SCRTD  
METRO RAIL PROJECT  
SAFETY CERTIFICATION PROJECT  
CRITERIA CONFORMANCE CERTIFICATION

CONTRACT A631

TRACTION POWER INSTALLATION

FIGURE 1

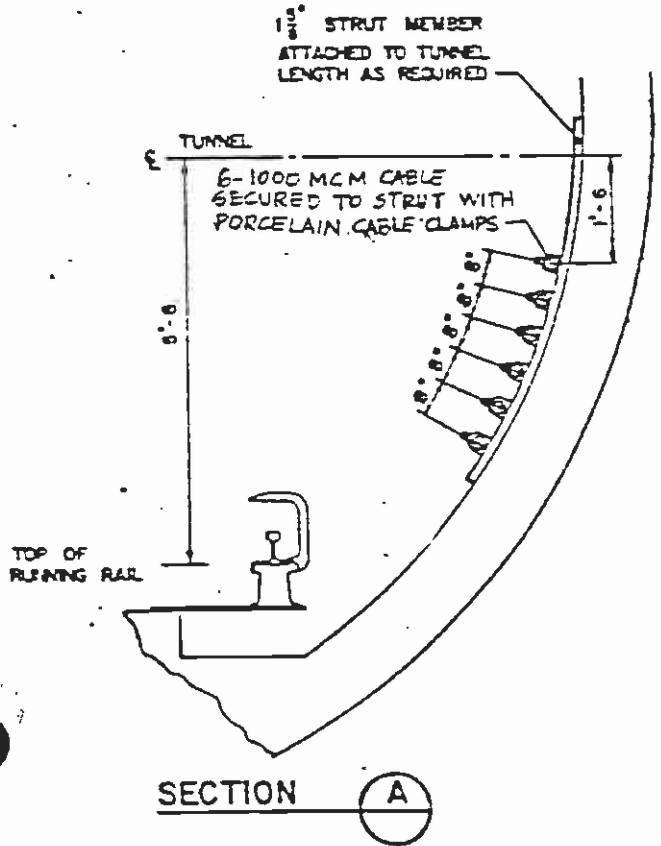
- o DC positive cables connecting disconnect switches to contact rail will be run exposed and mounted on support insulators attached to concrete walls/tunnel liners (see attached sketch Figure 1).

FIGURE 2

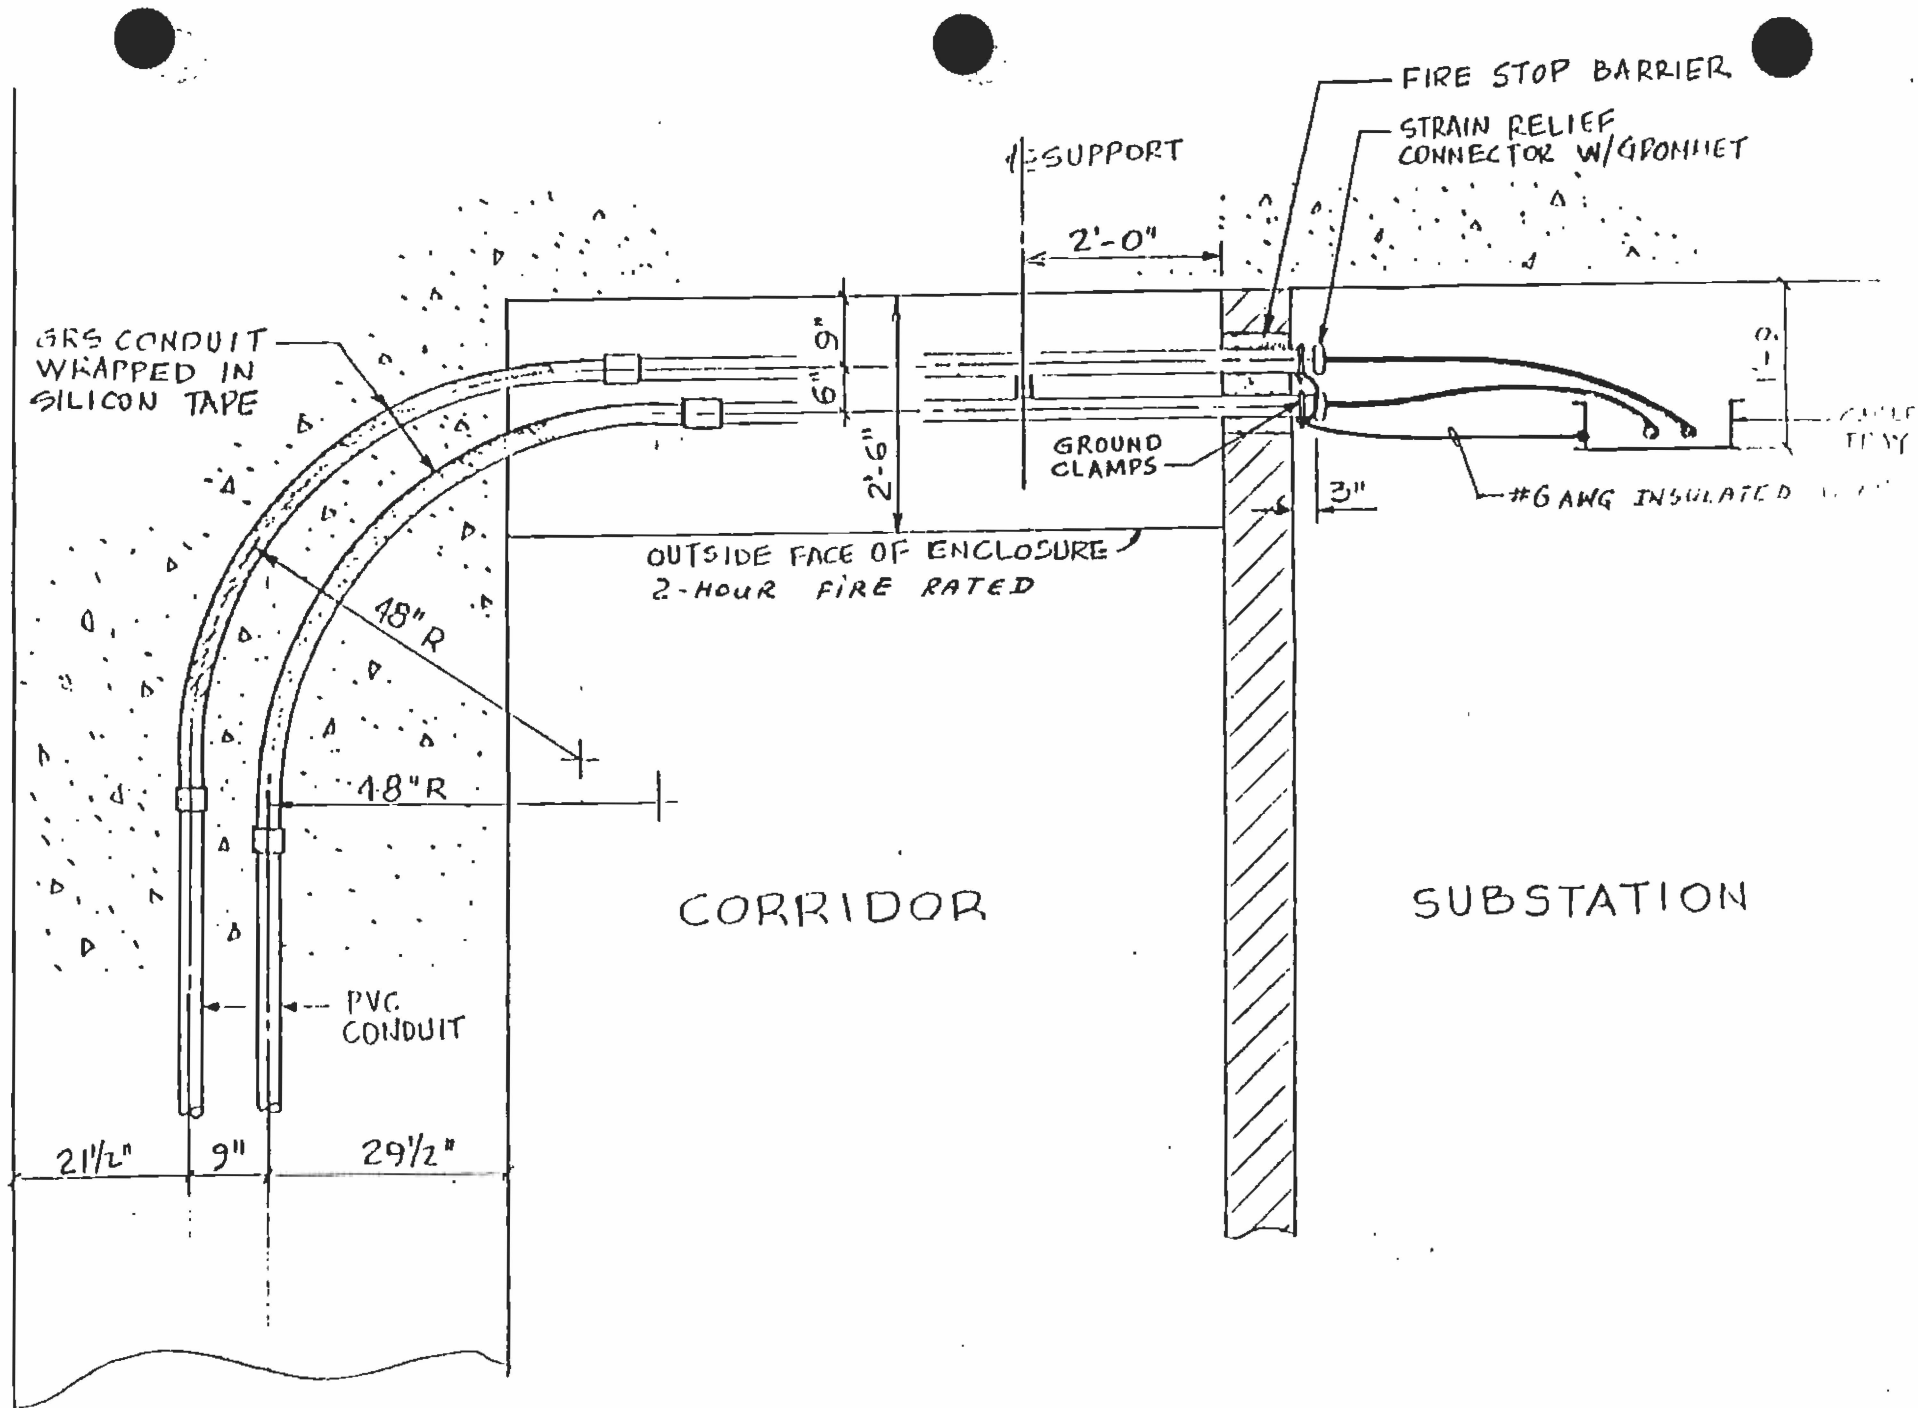
2. A.I. #181
- o DC positive and negative cables within exit corridors (outside substation rooms) will be run in exposed steel conduits. These conduits will be insulated from ground. Conduits housing dc positive cables will be connected to the associated cable trays (see attached sketch Figure 2).

- o A 2-hour fire rated ceiling assembly will be provided below the exposed steel conduits.
3. A.I. #184
- o Tunnel 35kv cable (three single conductors) will be run in 5-inch GRS conduit. No fireproofing will be provided around the conduit (see attached sketch Figure 3). Members of F/LSC indicated at the March 18, 1986 meeting that such design would be acceptable.
